Illinois Tollway Base Sheet Revisions

| Section M Base Sheet Drawings | | |
| Drawing | Modification Summary | Effective: 03-01-2019 |

BASE DRAWING M-OHS-730
SHEET 4 OF 9

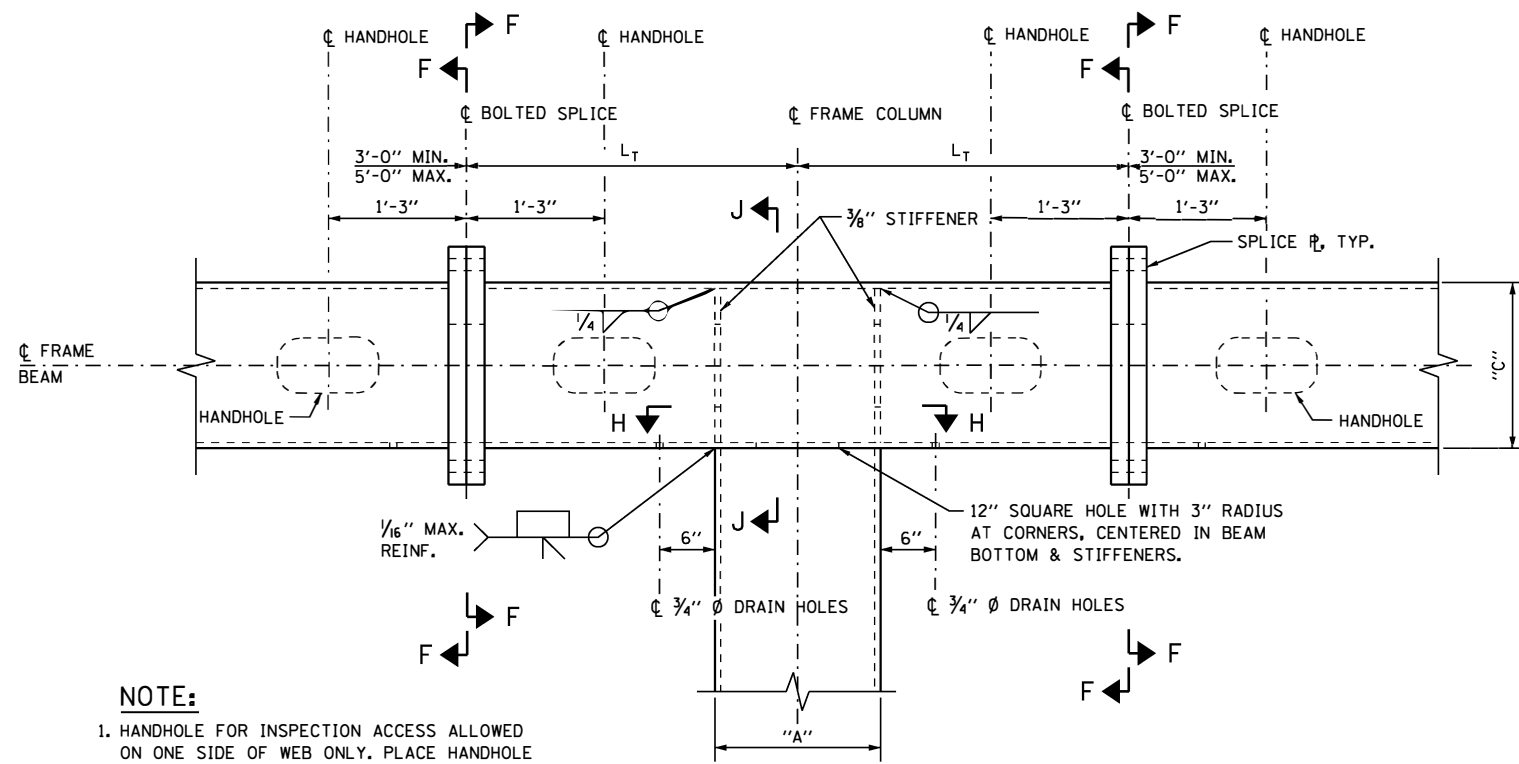
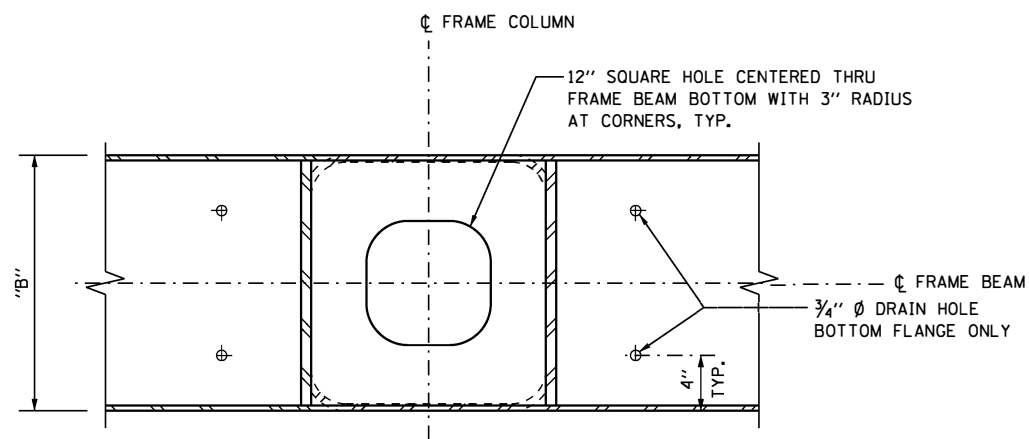
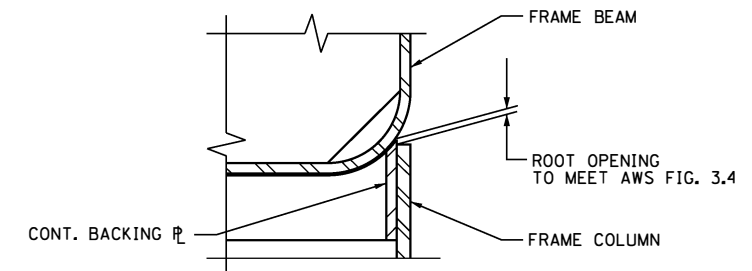
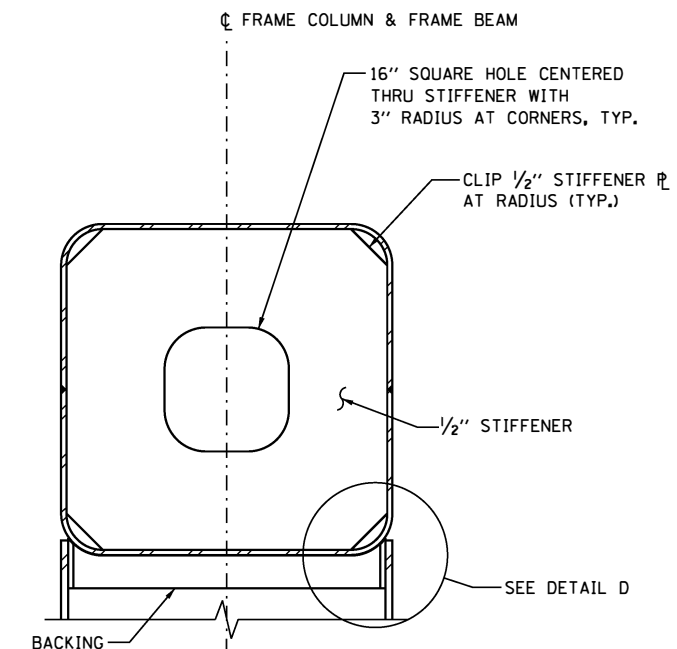
| Section M Base Sheet Drawings | | |
|---------------------------------------|-------------------------------------------------------------------------------------------------------------------------|------------------------------|
| M-OHS-730 | OVERHEAD SIGN STRUCTURE ITS GANTRY FRAME (STEEL) TWO-SPAN STRUCTURE DETAILS SHEET 4 | |
| | Increase opening of vertical stiffener plate from 12" to 16" square hole and thickness from 3/8" to 1/2" | |

BASE DRAWING M-OHS-730
SHEET 9 OF 9

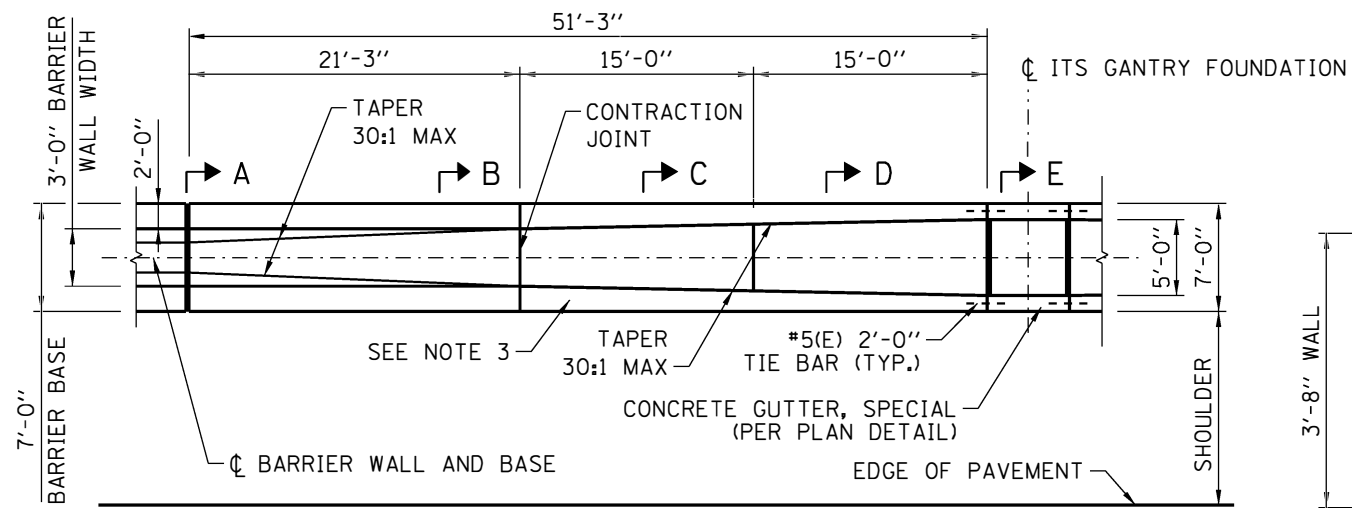
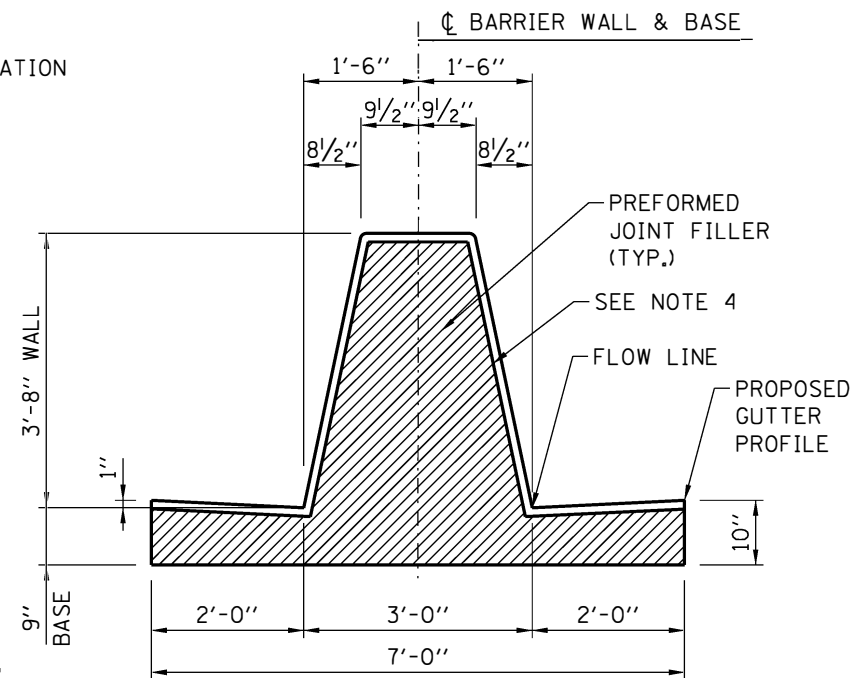
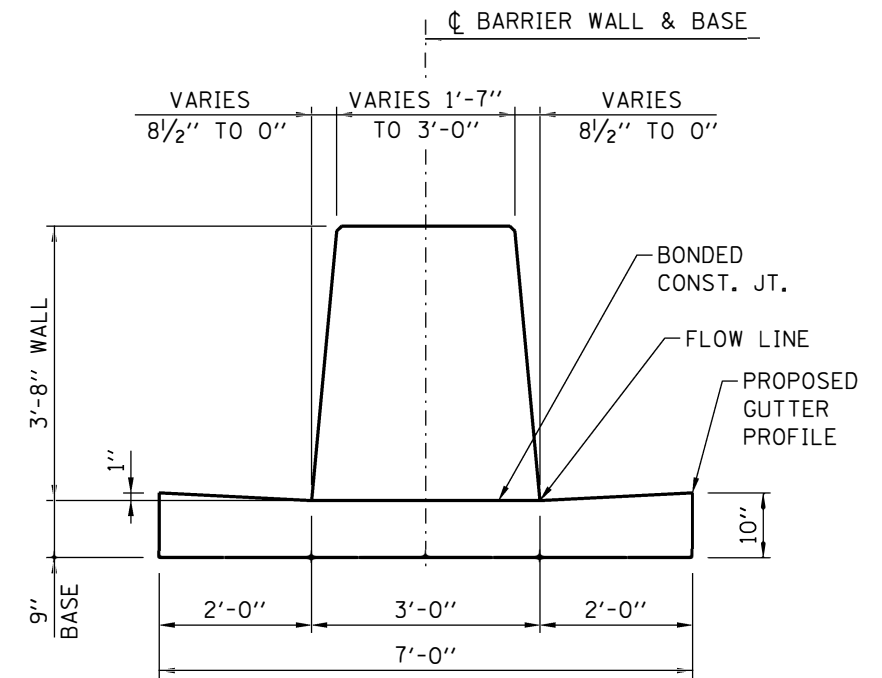
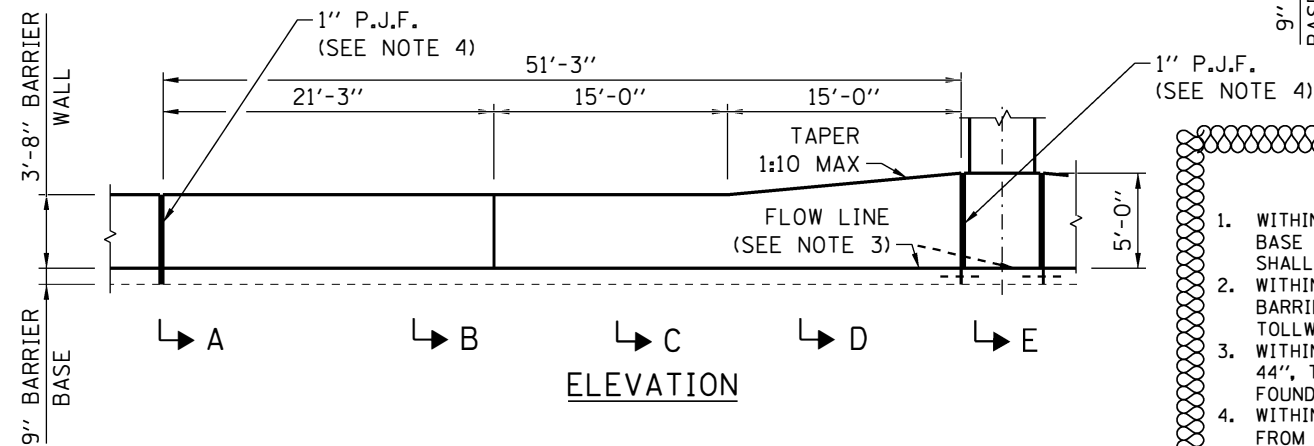
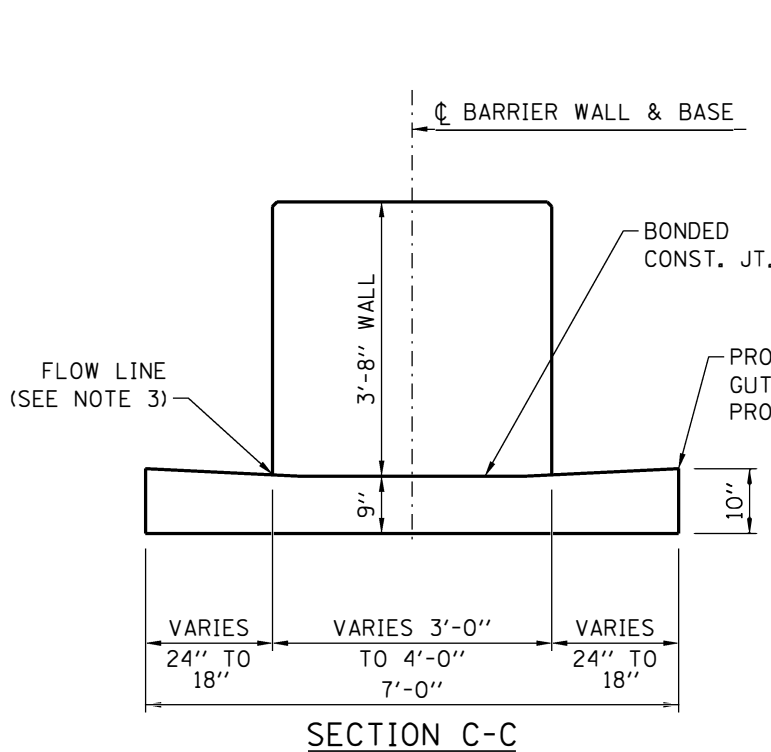
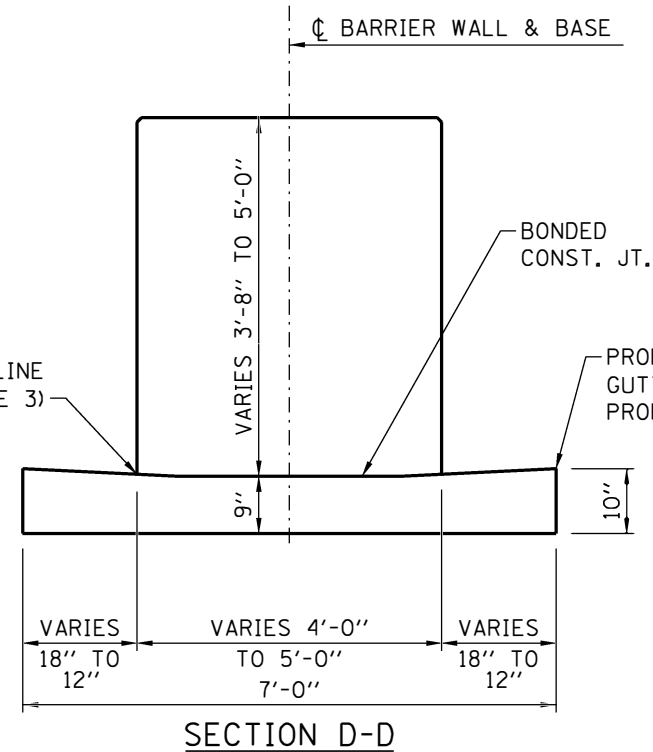
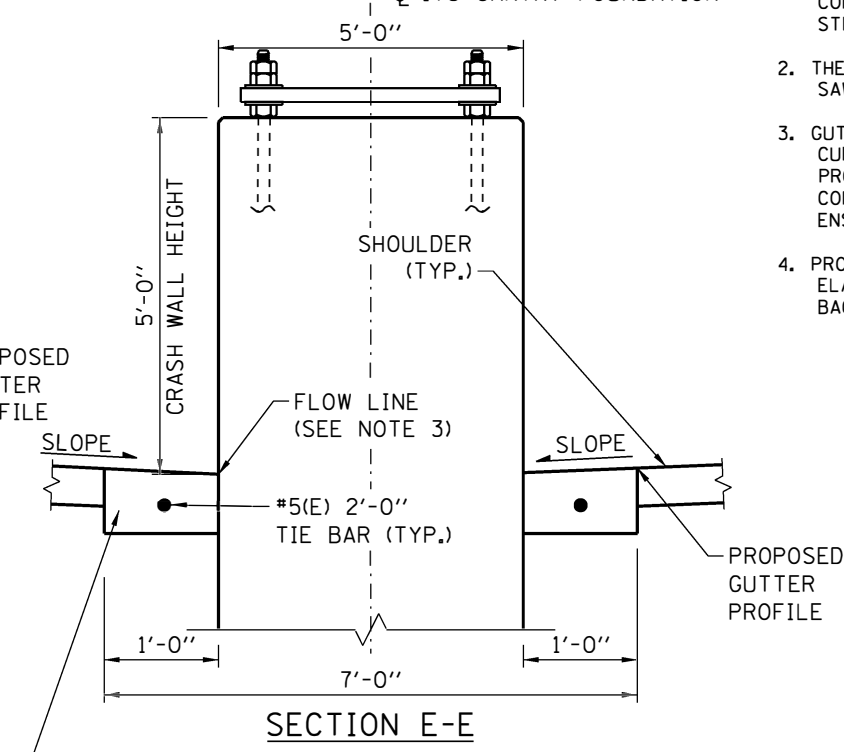
| Section M Base Sheet Drawings | | |
|---------------------------------------|-------------------------------------------------------------------------------------------------------------------------|------------------------------|
| M-OHS-730 | OVERHEAD SIGN STRUCTURE ITS GANTRY FRAME (STEEL) TWO-SPAN STRUCTURE DETAILS SHEET 9 | |
| | Update barrier shape and details for constant slope | |
